United States Patent and Trademark Office

APPLICATION NO.	FILING DATE	FIRST NAMED INVENTOR	ATTORNEY DOCKET NO.	CONFIRMATION NO
10/826,046	04/16/2004	Steven S. Homer	200315743-1	9457
22879	7590 11/16/2006		EXAM	INER .
HEWLETT PACKARD COMPANY			PAPE, ZACHARY	
P O BOX 272400, 3404 E. HARMONY ROAD INTELLECTUAL PROPERTY ADMINISTRATION			ART UNIT	PAPER NUMBER
FORT COLLINS, CO 80527-2400		2835

DETAILED ACTION

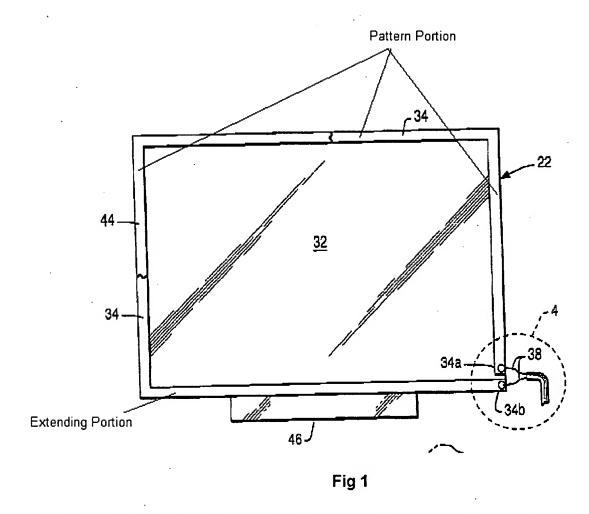
With respect to claim 18, Detwiler further teaches providing a screen (32) having a pattern antenna portion disposed on the interior surface of thereof (See Fig 3, see also POA Fig 1 above).

With respect to claim 19, Detwiler further teaches a screen having an extension portion extending from the pattern antenna portion to a screen connector (See POA Fig 1 above).

With respect to claim 23, Detwiler further teaches that the antenna (34) comprises a pattern portion (See Present office action Fig 1 below).

With respect to claim 24, Detwiler further teaches that the antenna comprises an extending portion (See POA Fig 1 above) extending from the pattern portion to a screen member connector (46).
